## Validation Report

### RENEWAL OF CREDITING PERIOD

BRT Bogotá, Colombia: TRANSMILENIO Phase II to IV

0672

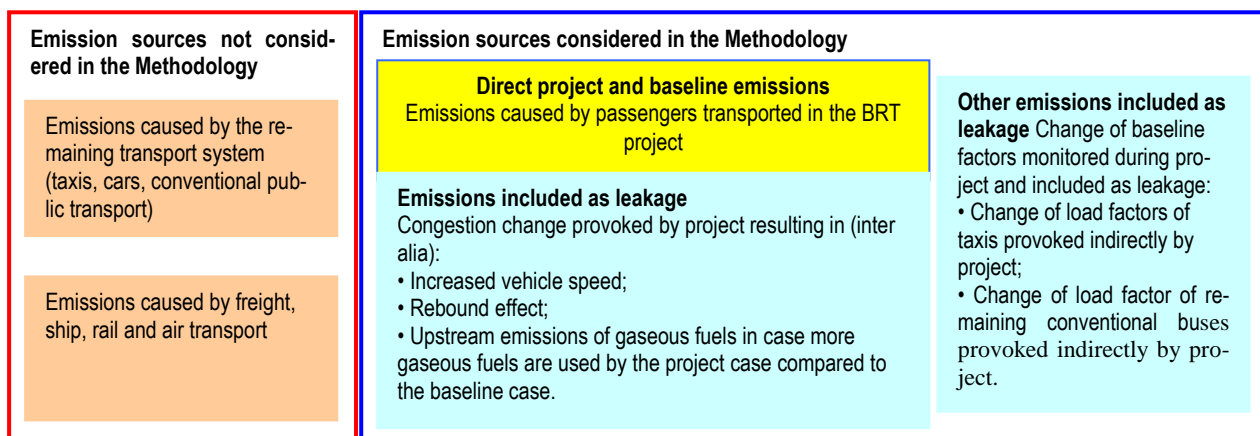
CL 9 DOE: The information Table 6 (page 12) is not limited to the project activity.

PP: This is correct. This table is copied from the original note and shows the entire TM network thus including Phase I trunk routes. An explanatory note has been added at the end of the table

DOE: Response accepted. OK

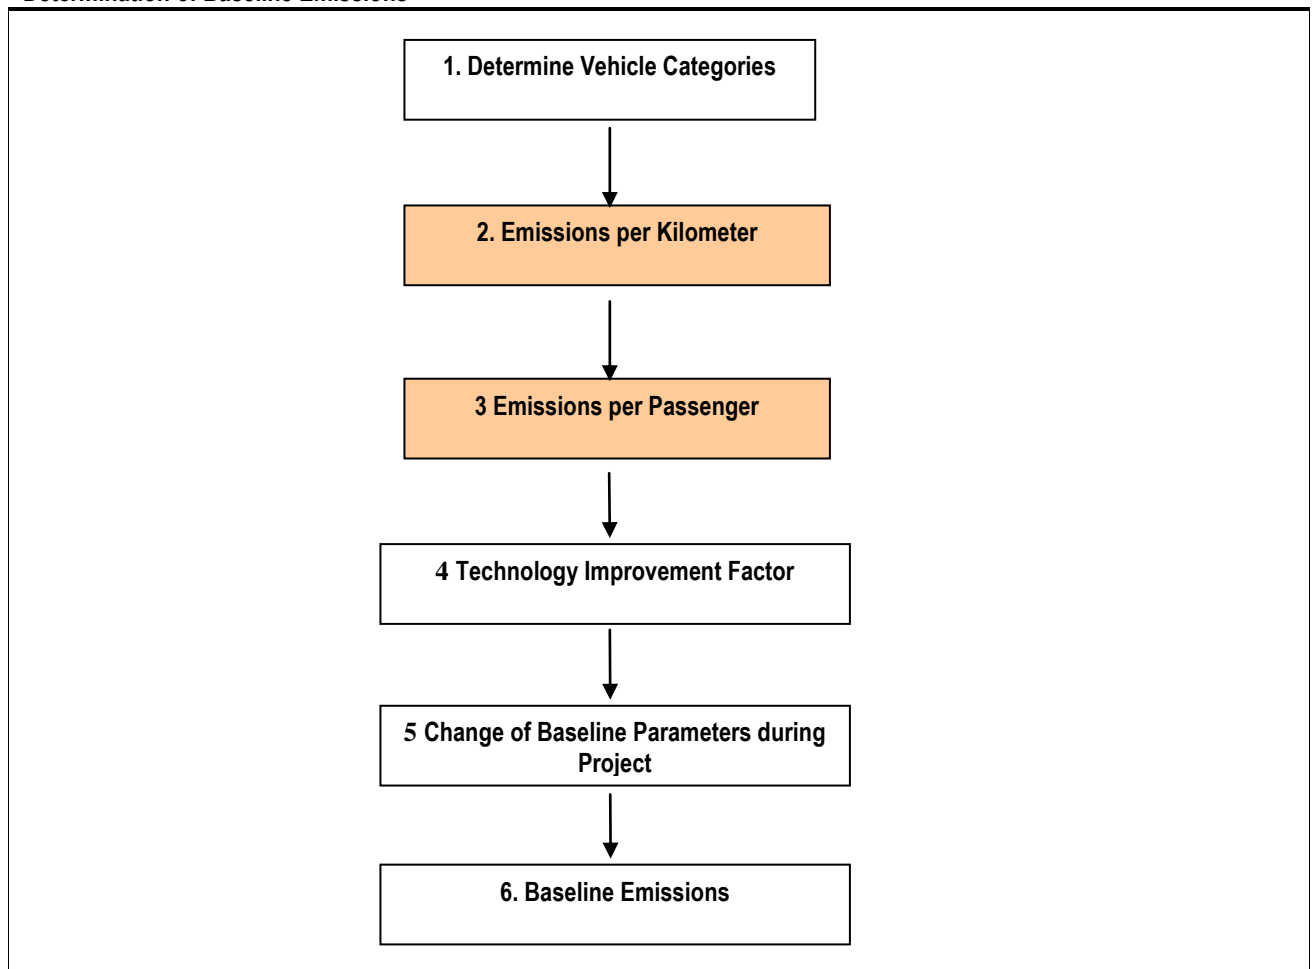
- "Project": Formula  $EF_{KM,j,y}$  is not consistent with PDD page 78
- "Baseline EF": IF 0.997 is for motorcycles, not for cars, buses, taxis. Text is not correct.
- "Leakage": The value for baseline occupation rate taxis is not correct because the link is not correct.

PP: The formulae in the sheet "Project" of the CER sheet has been adjusted.

The text IR (improvement rate) sheet "Baseline EF" has been changed to motorcycle.

The value occupation rate taxis in the sheet "Leakage" has been updated with the correct link.

DOE: Response accepted. OK
